ADDENDUM NO. 1
Penguin Life Support System Upgrade
REQUEST FOR BIDS #11-1717
August 11, 2010

THE FOLLOWING ARE CHANGES TO THE CONTRACT DOCUMENTS

SHEET NO.:
RP.01
 REFERENCE SHEET NO.:
1/P2.1

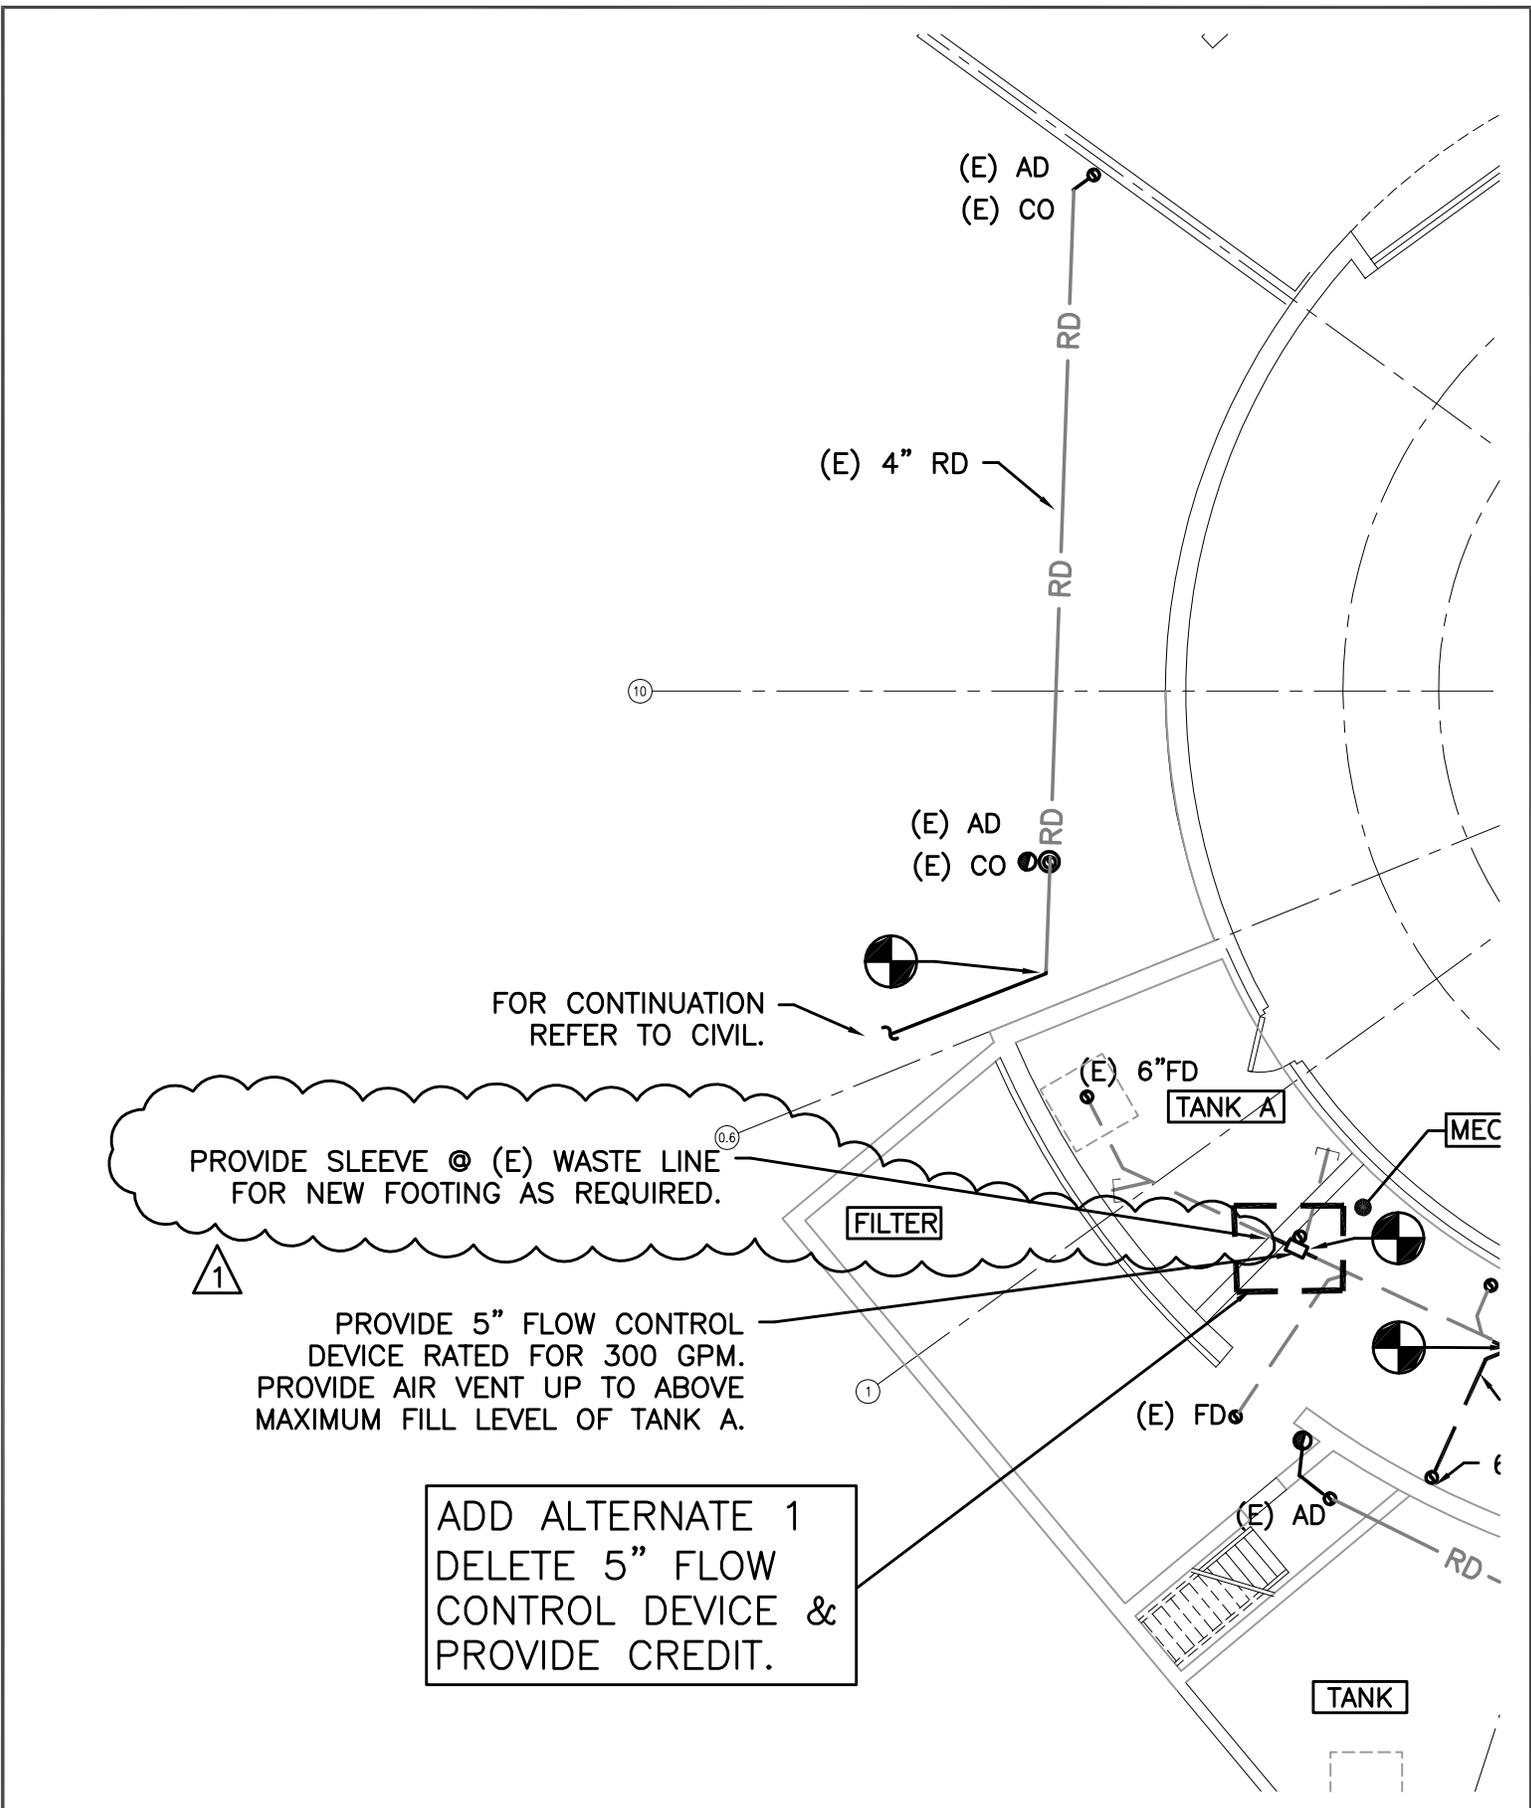
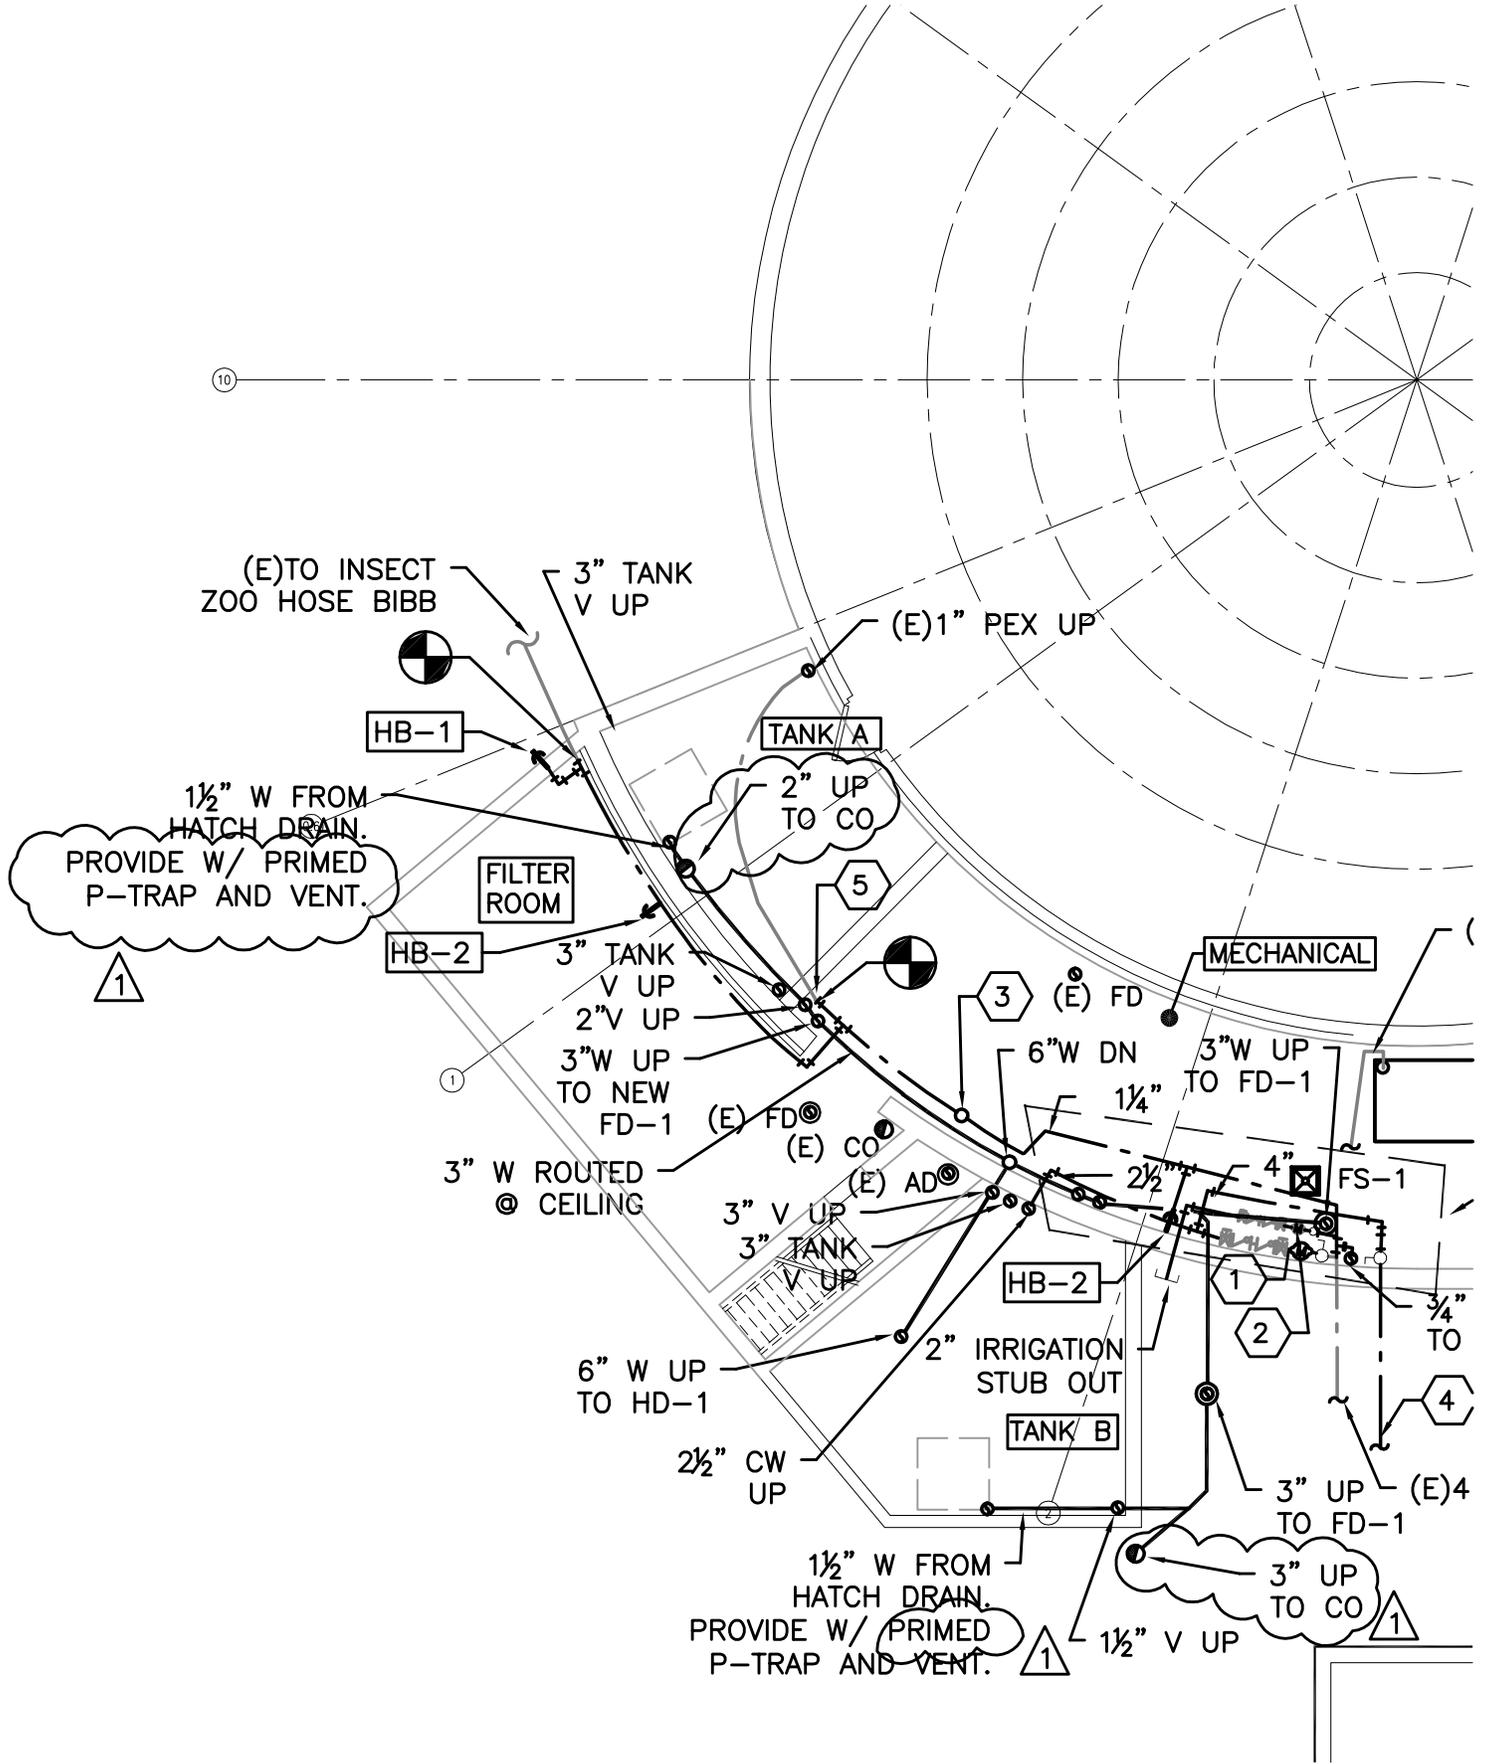
PROVIDE SLEEVE @ (E) WASTE LINE FOR NEW FOOTING AS REQUIRED.

PROVIDE 5" FLOW CONTROL DEVICE RATED FOR 300 GPM. PROVIDE AIR VENT UP TO ABOVE MAXIMUM FILL LEVEL OF TANK A.

ADD ALTERNATE 1
DELETE 5" FLOW CONTROL DEVICE & PROVIDE CREDIT.

SHEET NO.:
 RP.04
 REFERENCE SHEET NO.:
 1/P6.0

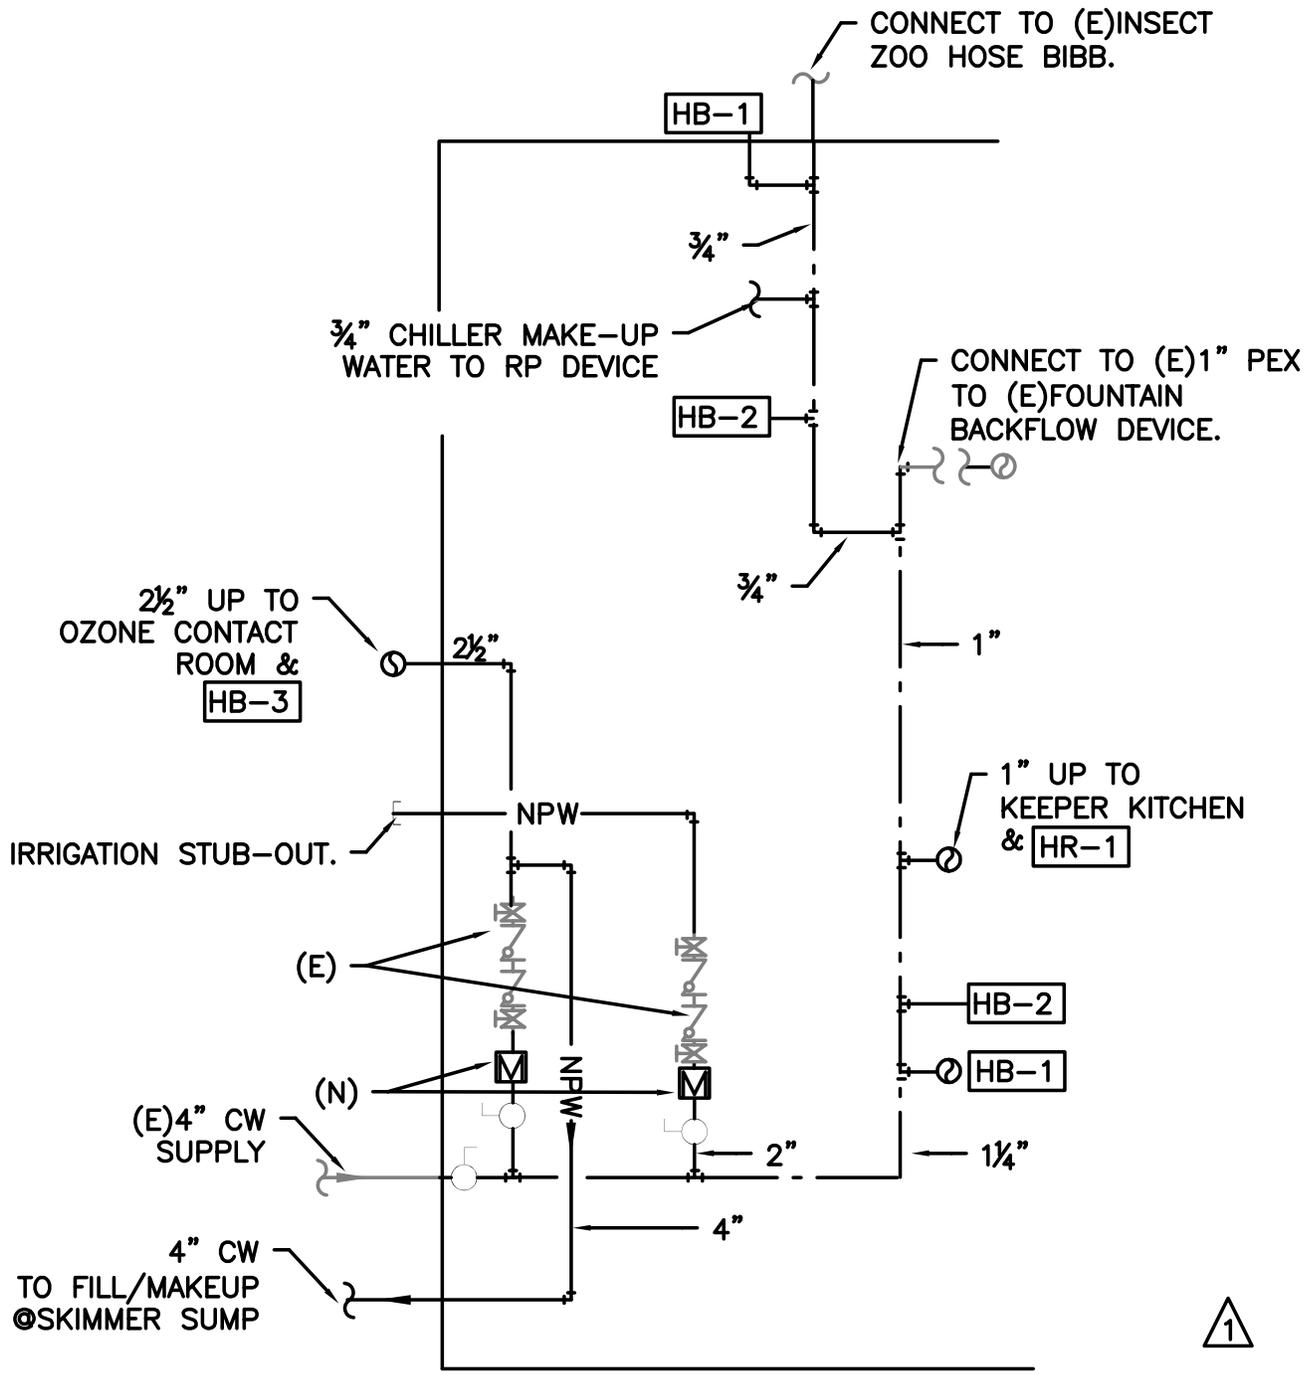
1. As shown on drawing.
- L. DRAWING RP.04 NAME: 1/P6.0 Plumbing Foundation Level Plan, REVISION MADE:
1. ADD Mechanical Room Piping Schematic 1/P6.0 as shown on drawing.

1 MECHANICAL ROOM PIPING SCHEMATIC
 P6.0 SCALE:NTS
